DEVELOPMENT REVIEW BOARD
SUPPLEMENTAL SUBMITTAL

PROJECT NO. PR-2021-005459
Application No. SD-2021-00163 SI-2021-01248

**RE: PR-2021-005459 RESPONSE TO DRB COMMENTS
LOT 1A BLOCK 2 & LOT 2-A-1 BLOCK 2 SUNPORT PARK
2900 TRANSPORT ST NE**

Purpose of Plat

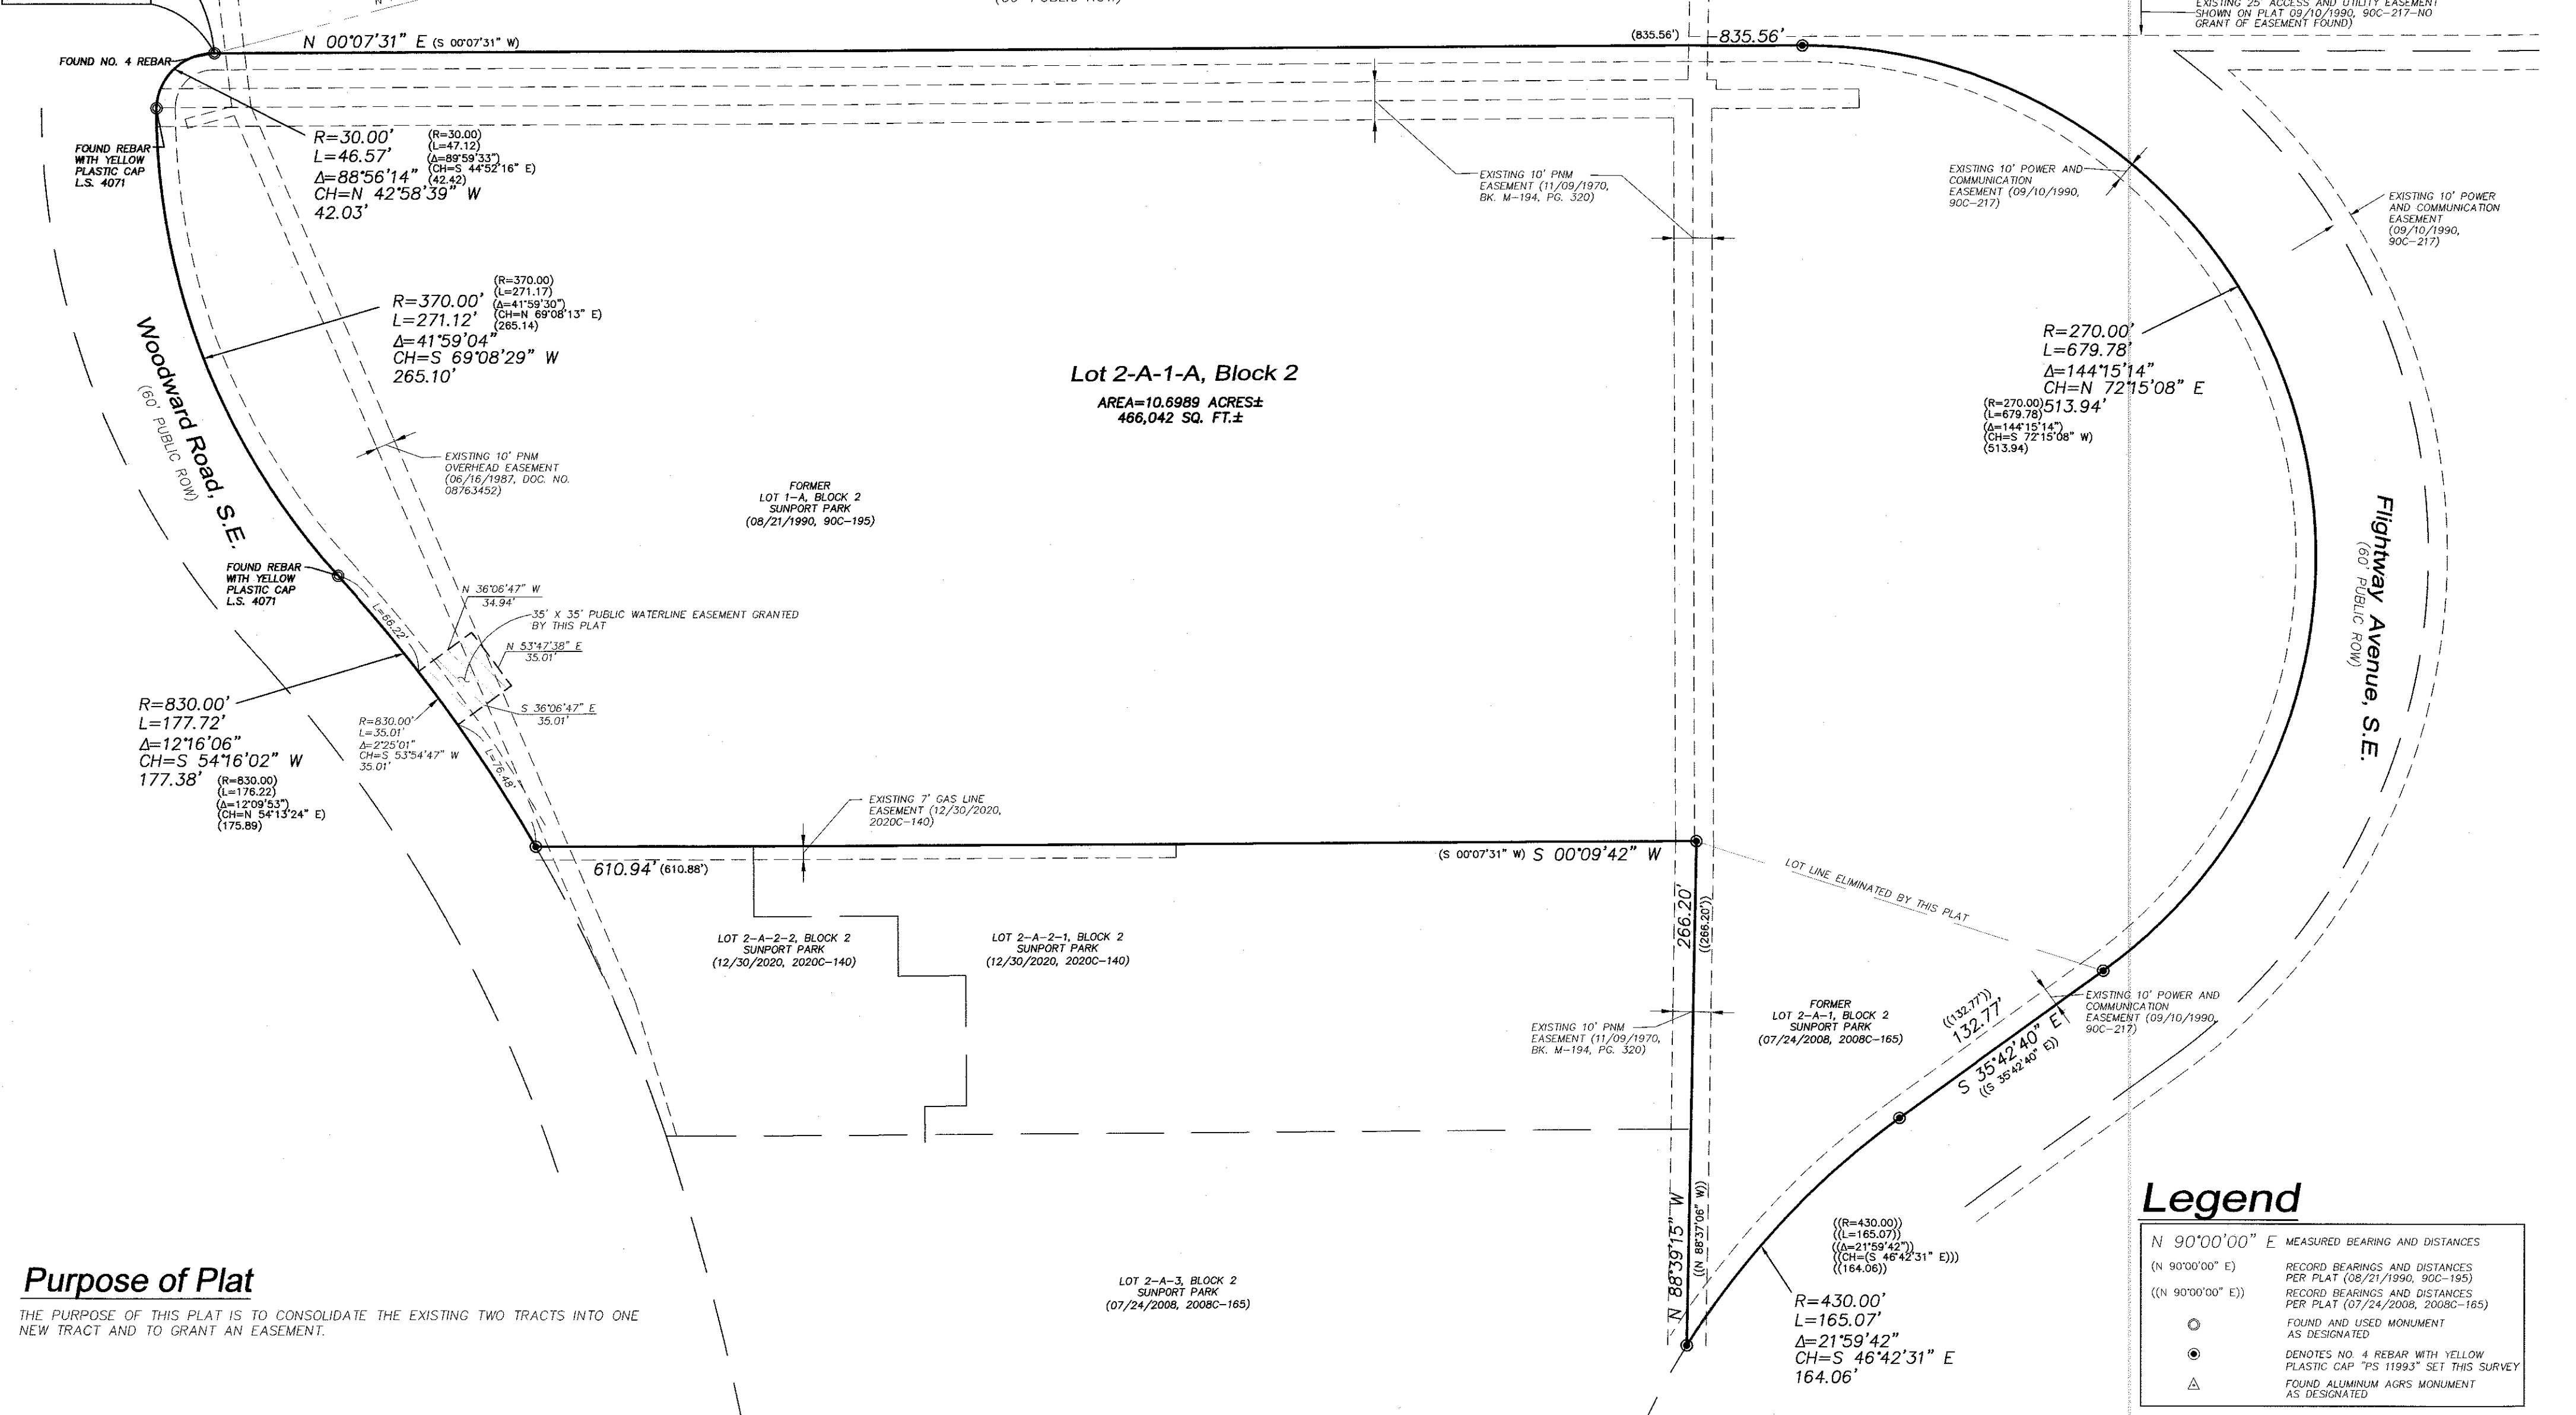
1. Please show the water meter vault easement or provide a paper easement.
RESPONSE: The plat has been updated to show a public 35'x35' water easement being granted with the approval of the plat. The updated plat is included with this submittal package.

1. The lot lines on the site (between Lot 1-A, Block 2 and Lot 2-A-1, Block 2) encroach on the delineated parking spaces in the northeastern portion of the proposed development. A Final Plat will need to be approved prior to final sign-off of the Site Plan from Planning.

RESPONSE: Noted. The intent of the replat is to eliminate the lot line between Lot 1-A and Lot 2-A-1 to make one consolidated lot.
2. The site is located within the boundaries of the Sunport Park Master Plan, and the proposed development will need to meet the requirements of the Master Plan. If there is a direct conflict between IDO requirements and the Sunport Park Master Plan, the Master Plan requirement governs. The applicant must provide the approved Master Plan for Sunport Park.

SITE PLAN FOR SUBDIVISION
SPSD1

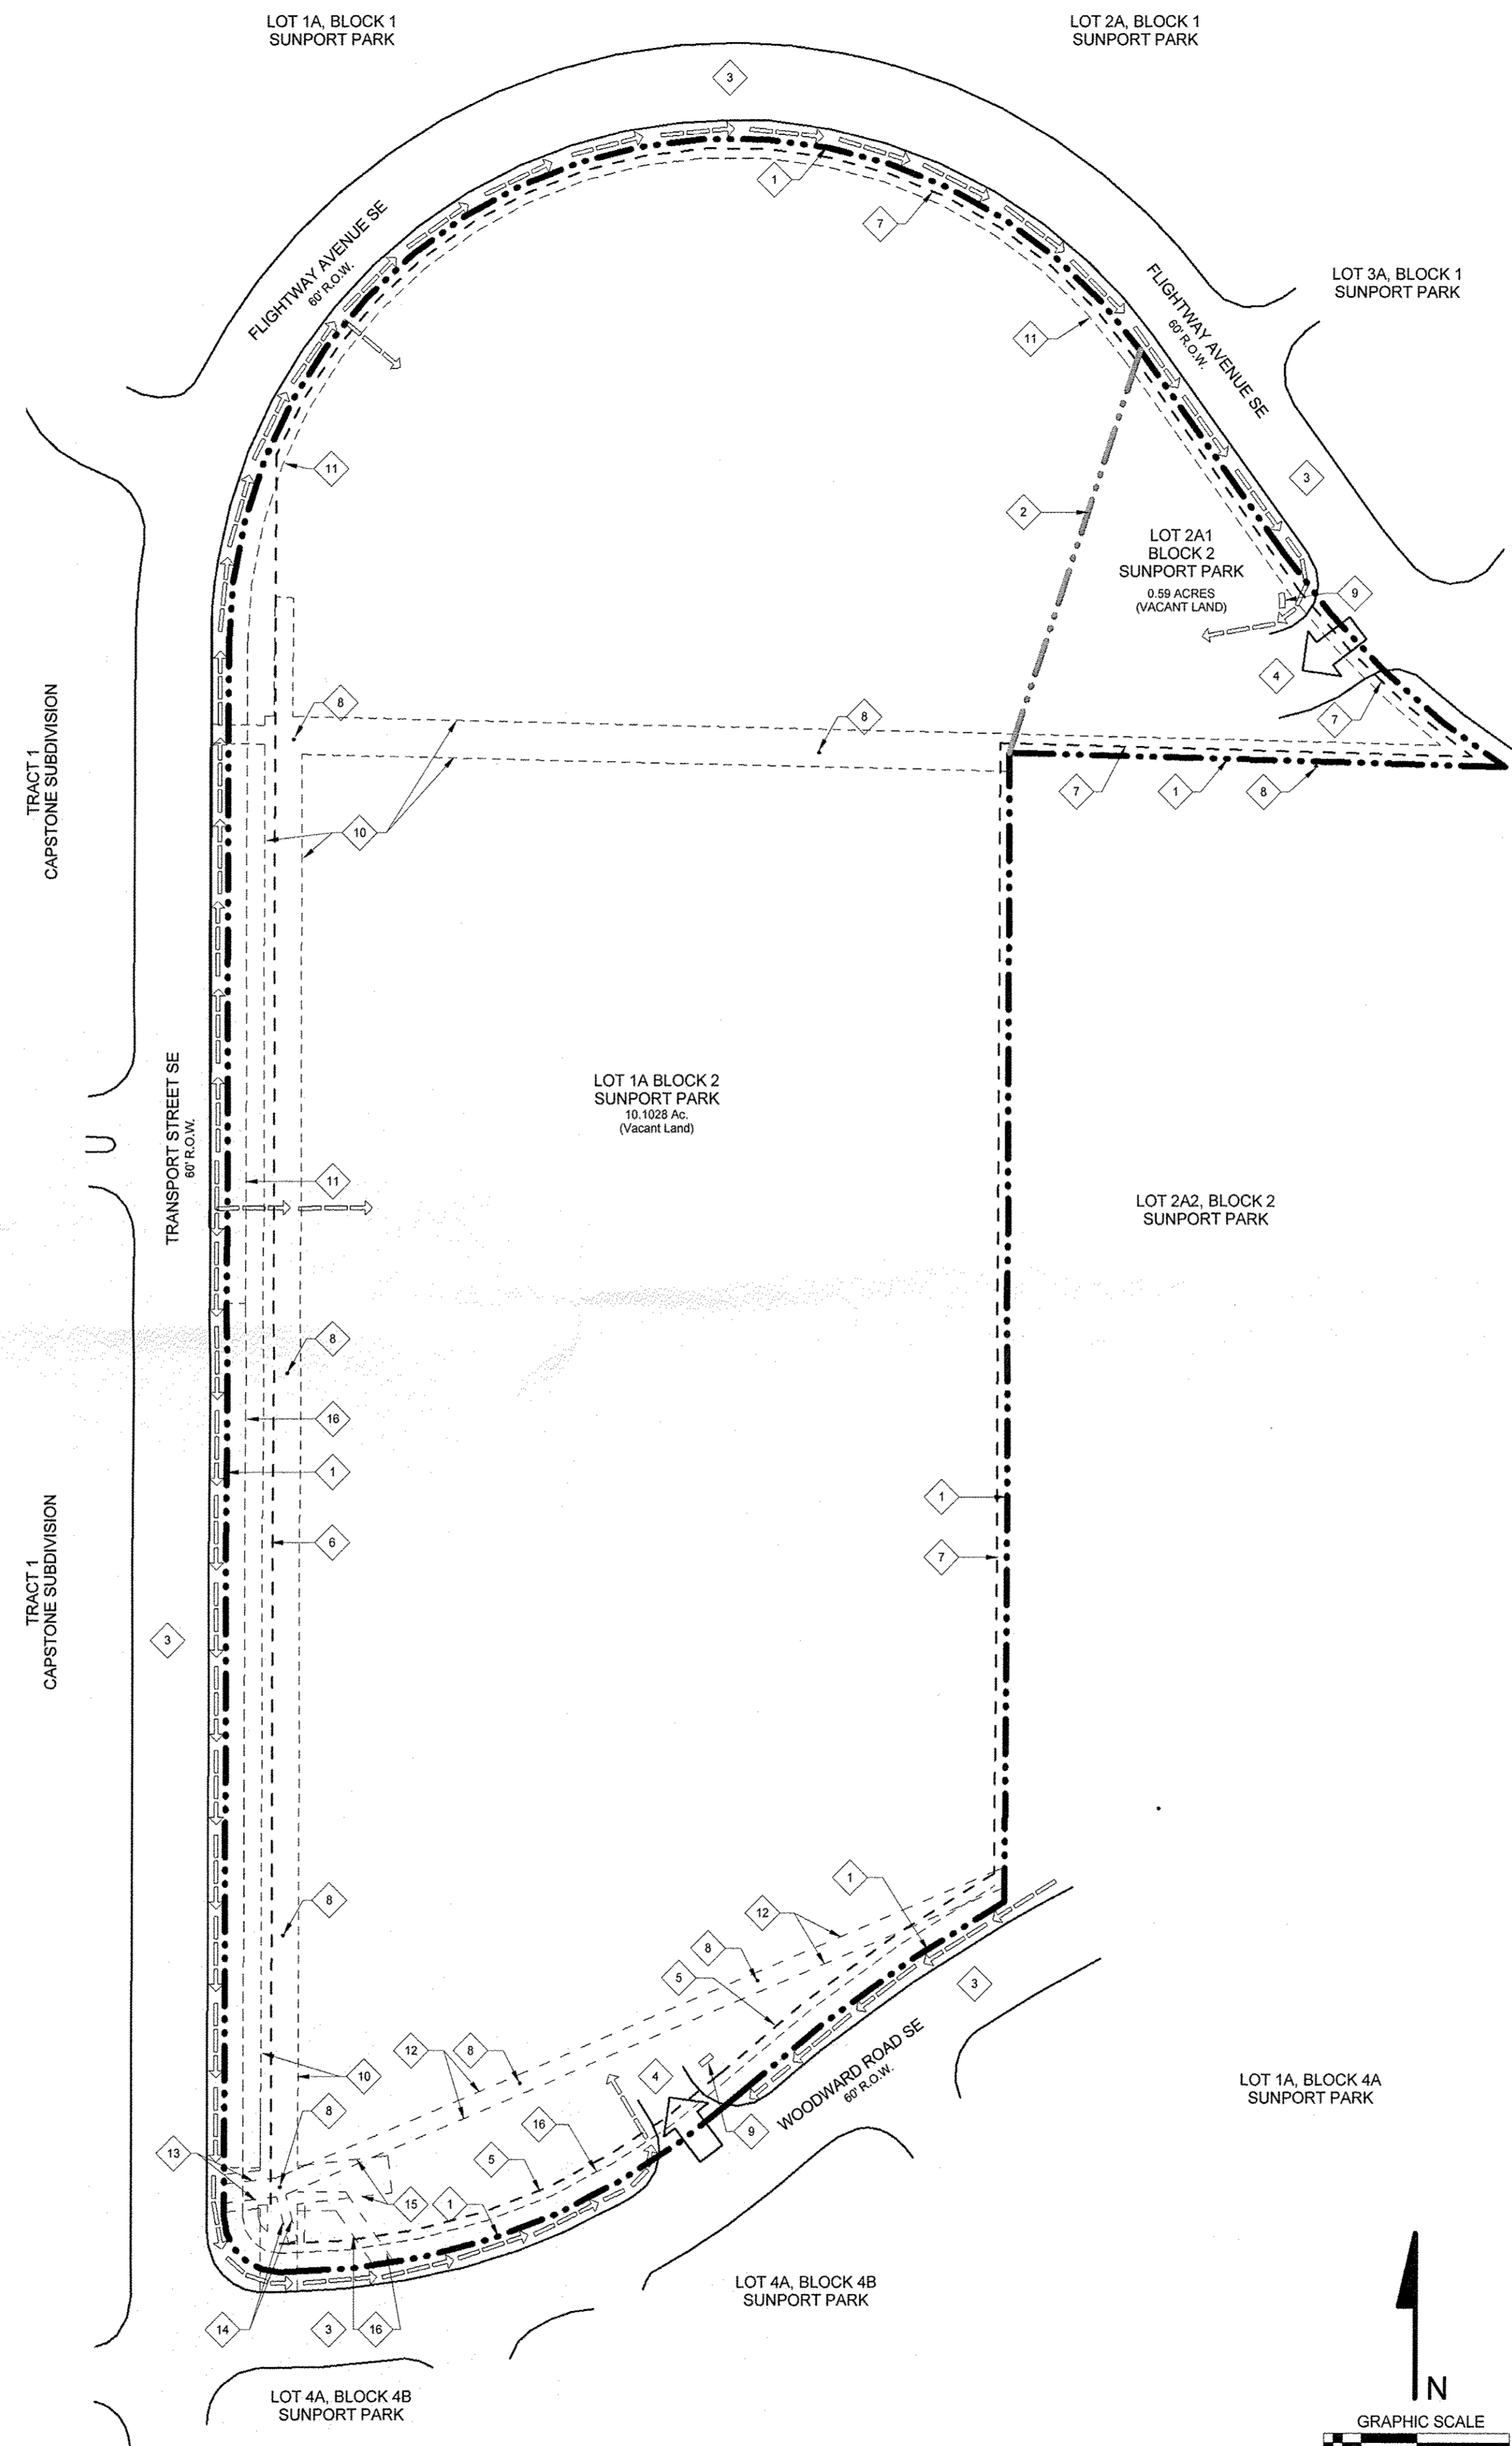
3. In the justification letter for the Site Plan submittal, the applicant noted that there was a previous Site Plan approval for multi-family residential development on the site. The applicant must provide the previously approved Site Plan.

RESPONSE: The Pre-IDO approved Site Plan for Subdivision is included in this resubmittal package.
